Product Change Notice (PCN)

Subject: Revision change of D2890 / CCE4503

QFN 3X3

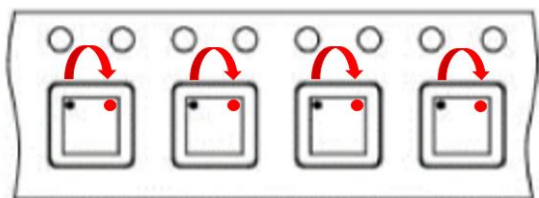
- 1) Change to revision BA
- 2) Change tape orientation (90 degrees clockwise rotation)
